**Before an Expert Panel
Bendigo-Ophir Gold Project**

FTAA-2507-1089

**SUPPLEMENTARY STATEMENT OF EVIDENCE OF DR LEANNE MORGAN
GROUNDWATER HYDROLOGY
RESPONSE TO RFI 11
7 September 2026**

Figure 1. Site investigation overview (Figure 1 in the Report)

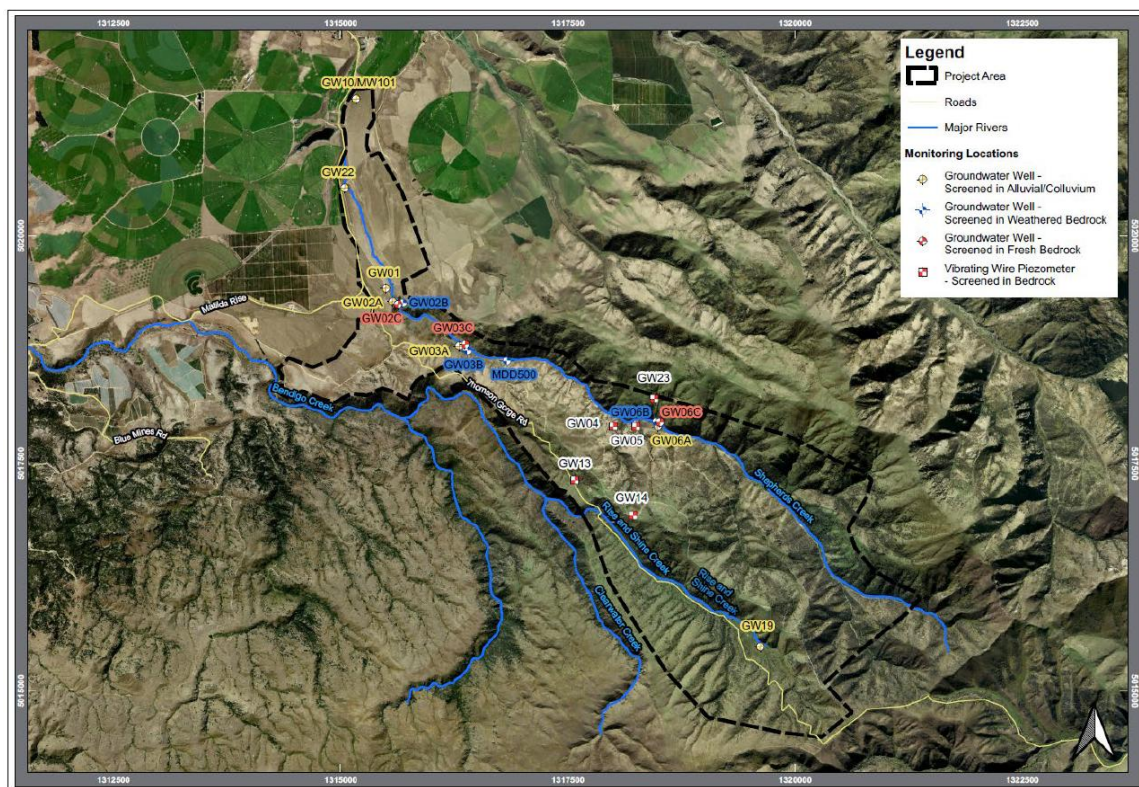
26. The location of the 10 new monitoring wells (GW02A/B/C, GW03A/B/C, GW06A/B/C, GW19) and 5 vibrating wire piezometers (GW04, GW05, GW13, GW14, GW23) is shown in Figure 1 below. Note that existing monitoring wells (GW01, GW10, GW22, and MDD500) are also shown on this figure as they were sampled for groundwater quality.

27. The 10 new monitoring wells are all located in the Shepherds Creek Valley bottom, apart from GW19, which is in the upper Rise and Shine Creek valley bottom. Monitoring wells GW02A/B/C, GW03A/B/C and GW06A/B/C are nested wells that are each screened across the alluvium/colluvium, weathered bedrock (schist) and fresh bedrock. These are in areas described as the Shepherds Creek Valley Alluvium, Shepherds Creek Valley Fill, Shepherds ELF i.e., at locations of proposed infrastructure. GW19 is in the upper Rise and Shine Valley bottom in the SRX ELF area and is only screened in the alluvium/colluvium. These monitoring wells are all relatively shallow with a maximum depth of 17 m.

28. The five vibrating wire piezometer strings, GW04, GW05, GW13, GW14, and GW23, are all located on the valley sides of the Shepherds Creek valley, with GW04 and GW05 closer to the valley bottom than GW13, GW14, and GW23. Each string has three sensors positioned at different depths, with placement depths across the five strings ranging from around 30 m to 200 m along the borehole, all within the TZ3 or TZ4 textural zones of the schist.

39. **The new investigation does not extend to areas the Panel identified, and experts agreed required further work.** Except for GW19, the new field work and groundwater quality sampling are confined to the Shepherds Creek valley. RFI 11 specifically directed that updated assessments address the potential adverse impacts on the Ardgor and Bendigo aquifer.¹⁰ Experts agreed in the Groundwater JWS that no baseline water quality

Figure 2 Shepherds Creek Valley Bottom Profile⁹⁵

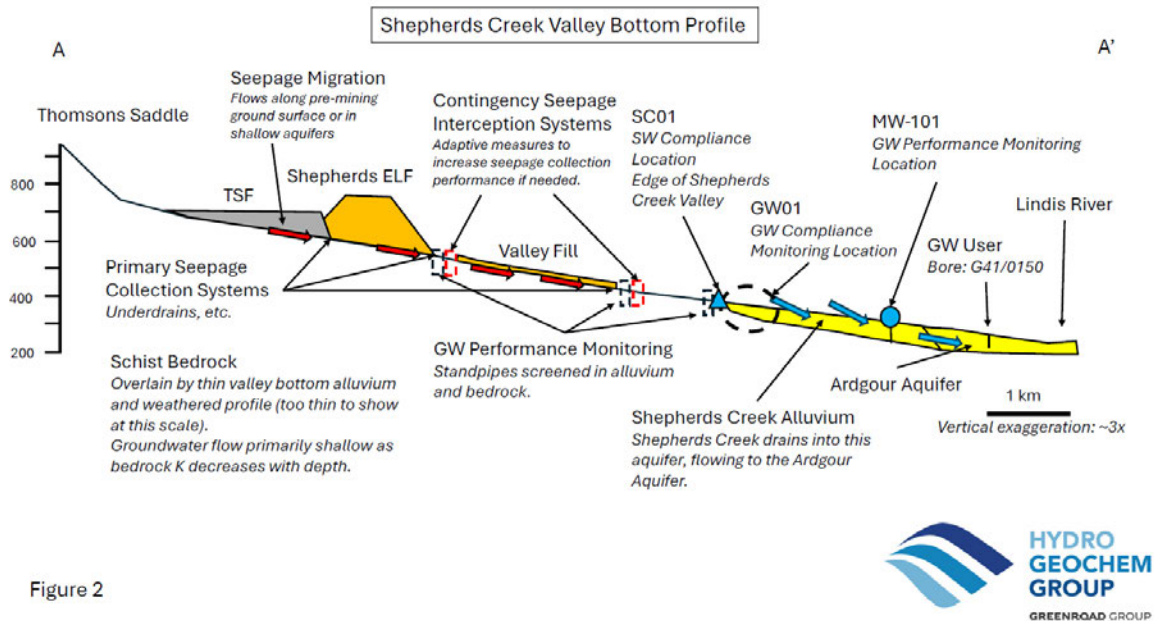
140. As shown in Figure 2, the Shepherds Creek Valley Fill ("SHFILL") is a further facility sited downgradient of the Shepherds Seepage Collection Sump, between the Sump and the SC01 compliance point. Condition 70's secondary measures cannot intercept seepage generated by SHFILL, since that seepage enters the valley flow path downstream of the Sump. SHFILL was one of the three sources included in the groundwater model, and had the highest lost seepage results of the three, up to 10%.⁹³ The Report describes adequate SHFILL underdrainage as essential, while also acknowledging the drains may suffer damage or blockage over their operational life.⁹⁴ Figure 2 also shows a second, downstream contingency interception location near SC01, but I could not find it addressed in the current conditions. In my opinion, the conditions should identify how seepage from SHFILL that is not captured by its primary underdrainage will be intercepted and conveyed to treatment.
